MURRAY CITY PLANNING COMMISSION

NOTICE OF MEETING AND AGENDA

August 01, 2024

4. Cottonwood Galleria - 4998 South Galleria Drive

Figure 1: Phasing Plan

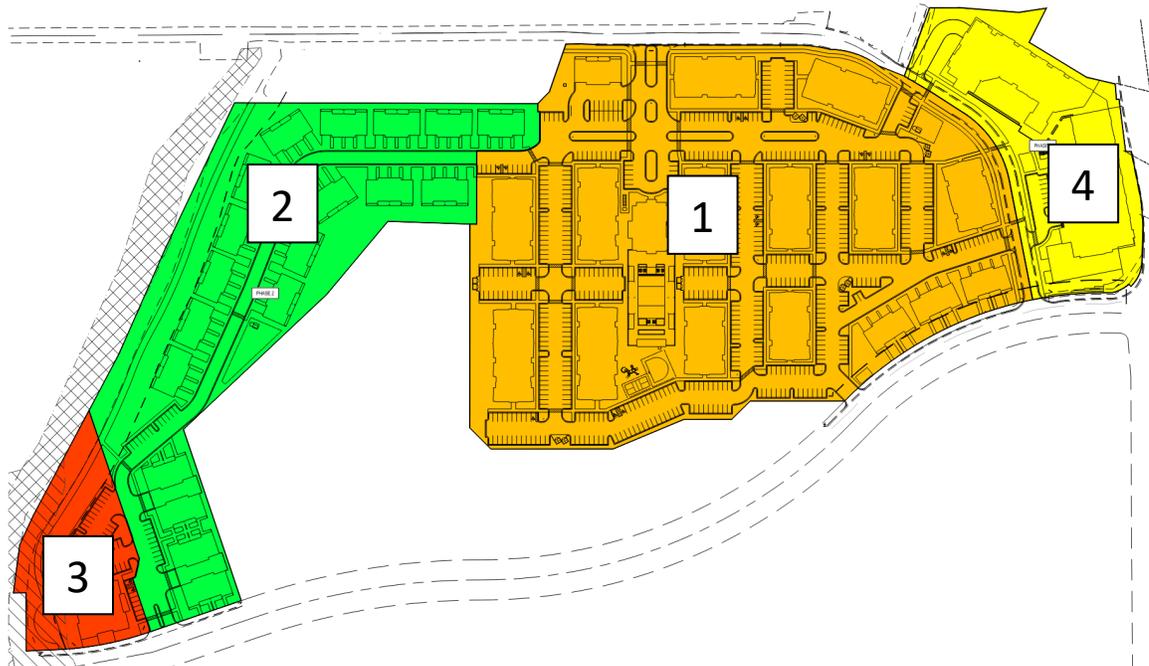
Concerns: site improvements, timing of commercial,

The applicant meets the requirements of the ordinance, staff recommends that the Planning Commission discuss whether the applicant install the Little Cottonwood Creek Trail as part of Phase 1 of the development. This will have a larger impact to the community as it is included as a central feature of the project.

SEE DRAWING C-304

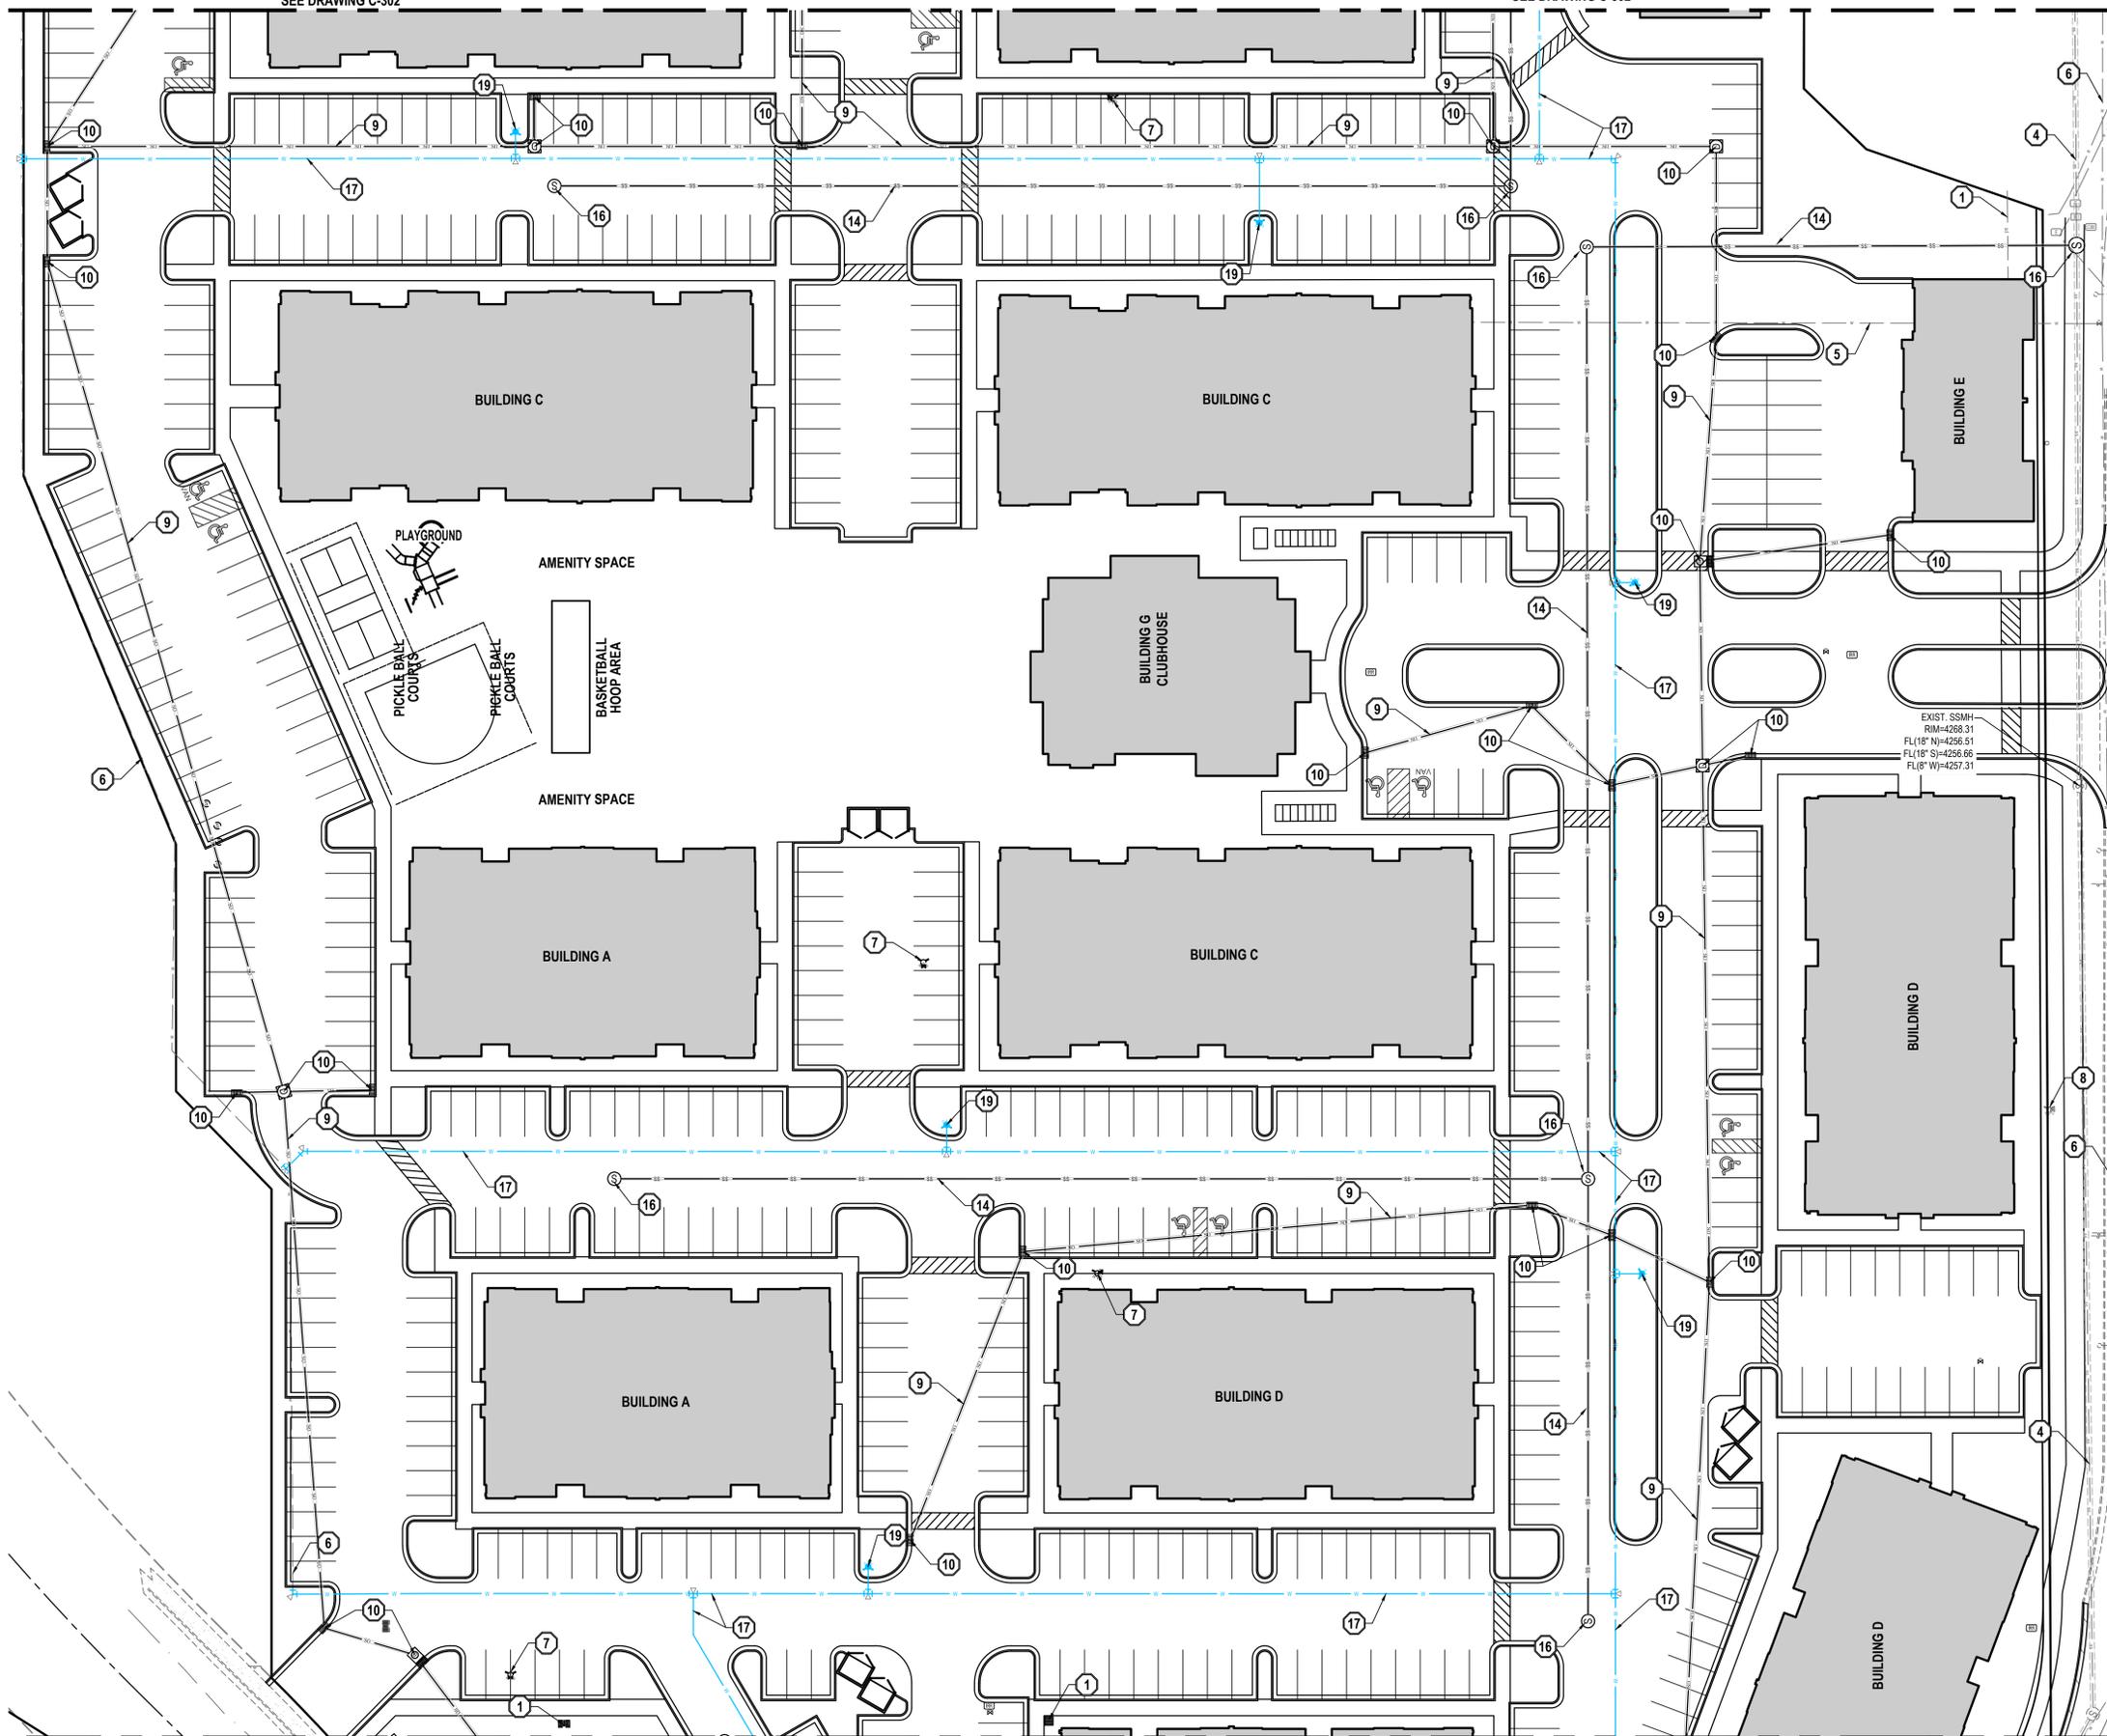
1. Sheet C-304 UP- New 15" sewer main on Southwest corner of development must be moved out into Murray Blvd. This will not be allowed to run through the private property.
2. Must be a minimum of 20 FT of separation between the corner of the building and the existing sewer line that will remain in Vine Street.
3. All manholes should be called out with sizing 5FT vs. 4 FT.
4. Utility sheets must show where building connections will tie in to the main
5. All utility work must be completed at the beginning of the project including phase 4 sewer work.
6. Include note on Utility sheets all sewer work must meet Murray City Wastewater Standards and include all details directly from Murray Wastewater Specification book.
7. <https://www.murray.utah.gov/DocumentCenter/View/14929/Revised-Wastewater-Spec-Book-2023>
